SERVICE BULLETIN

SERVICE BULLETIN NO: 53-006

ENGINE MOUNTING-FRAME ATTACHMENT-FITTINGS - INSPECTION

Engine Mount Attachment Fittings - Inspection/Repair Figure 1

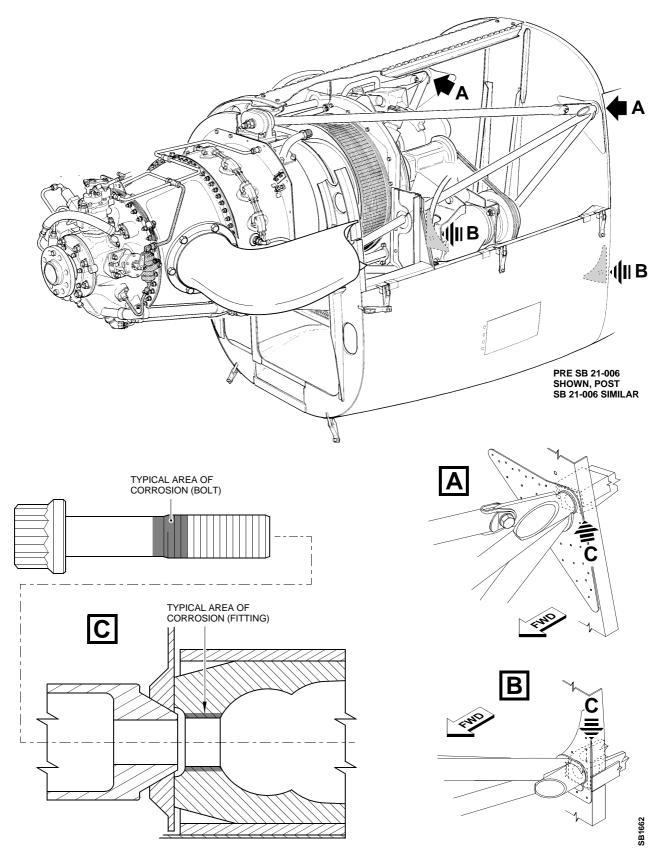
A. Inspection/Repair (Ref. Fig 1)

- NOTE: It is not necessary to remove the barrel nut to do the inspection.
- (1) Remove the bolt and washer from one of the four engine mounting-frame attachment points (Ref. AMM 71-20-01, Page Block 401).

- (2) Do a visual inspection for corrosion on the removed bolt.
- (3) Do a visual inspection for corrosion in the bore of the attachment fitting. Do this with a boroscope. If you find corrosion, do the subsequent steps:

- (f) If necessary, install the barrel nut and/or the engine mounting frame.
- (4) Install the new bolt (P/N 115.45.07.047) and the washer (P/N 938.75.11.104) (Ref. AMM 71-20-01, Page Block 401).
